STAFF REPORT:

C.U.P. 21-27 Timber Creek Reserve - Preliminary Plat

October 14, 2021

# TIMBER CREEK RESERVE PROPOSED SUBDIVISION STREET NAMES AND LOTS

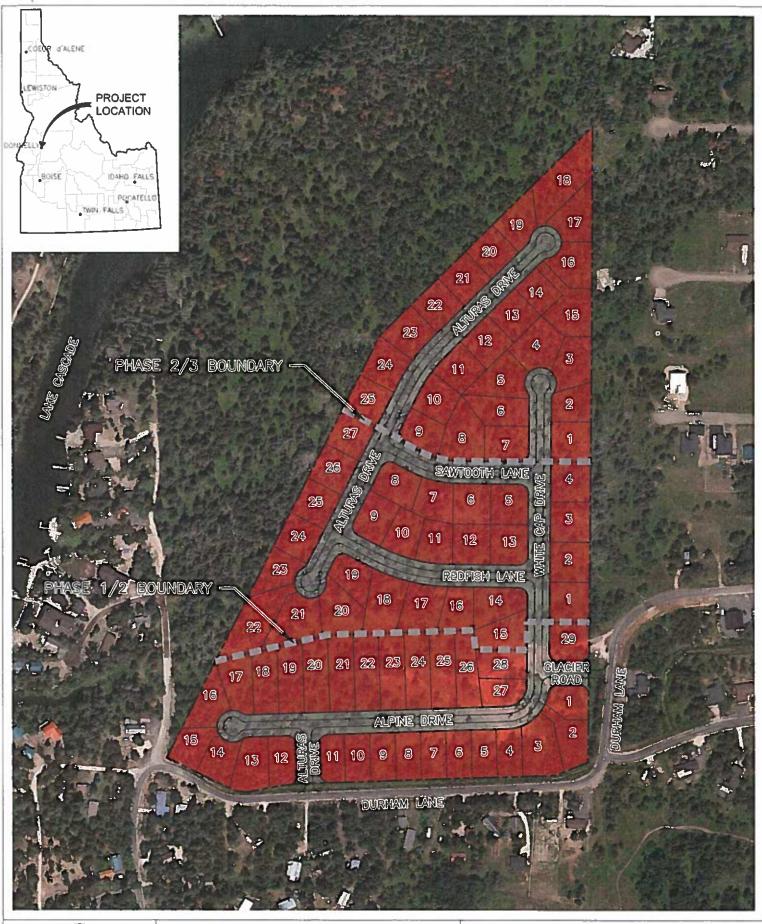
Kelly Copperi, Communications Supervisor, and Laurie Frederick, Cadastral Specialist, reviewed the proposed road names. These proposed road names are not acceptable: Sawtooth Lane and Alpine Drive. (Sept. 22, 2021)

Alturas Rd - I'm good with this one Sawtooth Ln - I am not good with. Anything Alpine - I am not good with. Glacier - I'm good with White Cap - I'm good with.

I show that we currently have: Sawtooth Ct. Alpine St. & Alpine Heights Rd. You may want to review these. Thank you,

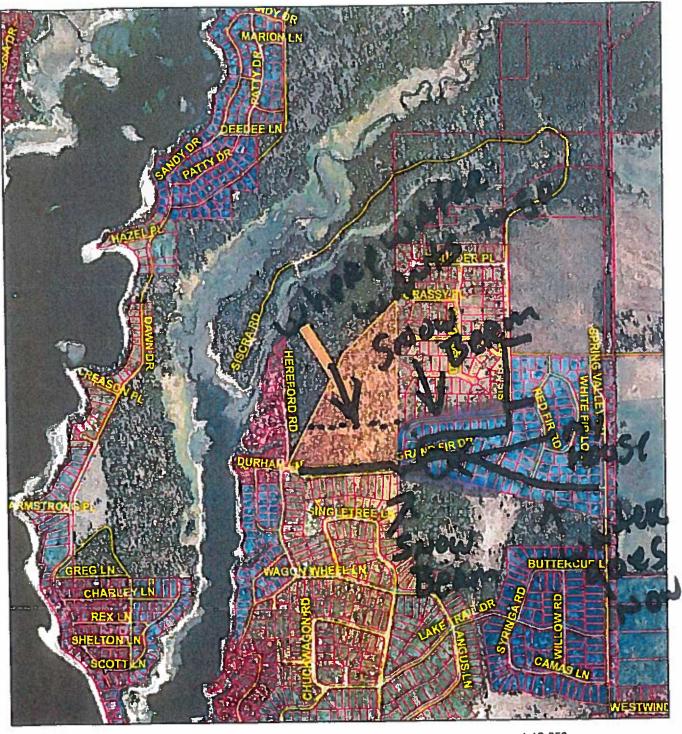
My name is Greg Tino (go by Phil). My wife Cathy and I have a house at 50 Grand Fir. We are very concerned with this new subdivision being proposed about the water drainage from winter snowpack. Currently we are very opposed to this being built. I have attached a couple of the diagrams we were mailed with some lines I have drawn on there to illustrate our issues with this new proposal. First, the solid black line represents where the water is currently supposed to drain into Lake Cascade. In low snow pack years this can be just ok. But with large amounts of snow or a bunch of rain causes our back yard to flood and turn into a reservoir. The reason for this as you can see by the purple highlighter is the snow berm we have from the snow plows acts like a dam until the water can drain out. The dotted line represents where the water naturally wants to go. In high snow pack years we have to dig that berm out causing massive amounts of water to go right in the middle of this new proposed sub division to keep our home from flooding. If this subdivision is built without a drainage plan, it will probably flood the new homes that would be built. Not to mention that with all the raised foundations and asphalt the water really has no place to drain and will back up further. I have had Jeff Mc Fadden with Valley County out several times to discuss this problem. He has seen it firsthand. I think one of the main problems in this area is that is from very old to very new and each time some new subdivision is built the developer just directs the water out of their planned area. Making it someone else's problem. Our home will definitely flood if this is built without addressing this major issue. I really hope this is all taken seriously. As is, we do not think this is a responsible thing to approve without the drainage of the snow pack being addressed.
